RE: Amended Definitive Subdivision – MGL Ch. 41 §81-W
Construction Plans – Phase 2
McGovern Boulevard, Lancaster, MA
Peer Review Comment-Response

On behalf of our client, North Lancaster, LLC, Hannigan Engineering, Inc. has reviewed the peer review comments from Haley-Ward regarding the application for an Amended Definitive Subdivision submittal for McGovern Boulevard, in Lancaster, Massachusetts. We offer responses to their comments below.

PROJECT LOCATION
 McGovern Boulevard,
 Lancaster, MA
 DRAWING TITLE
 Conceptual Intersection
 Improvements

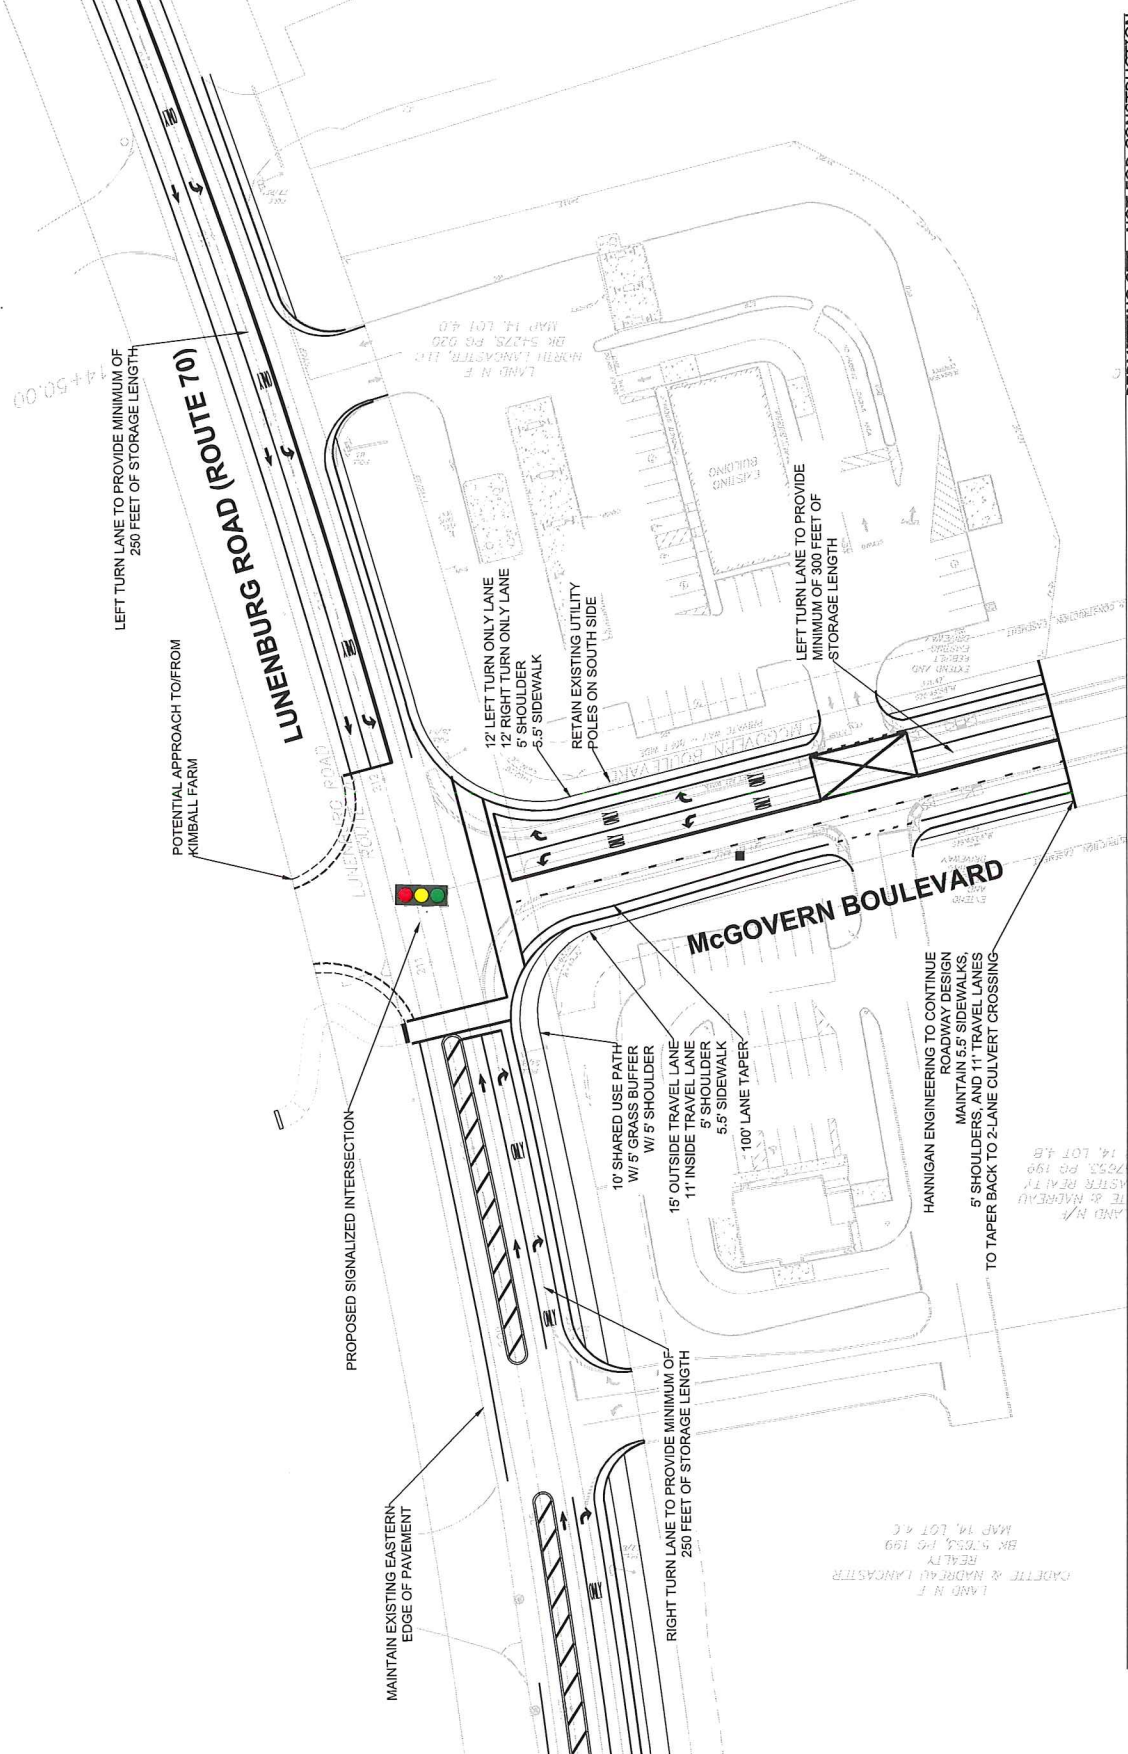
Comment #7: The plans indicate proposed signalization at the McGovern/Lunenburg intersection. The plan for implementing this work should be presented.

Response: As stated above, the design of the roadway improvements as submitted are based on those plans as prepared by TEC. These plans are at the Conceptual Level as part of the MEPA review process. Further design and permitting from MassDOT will be required for the construction of this intersection. The Conceptual Plan has been included in this review.
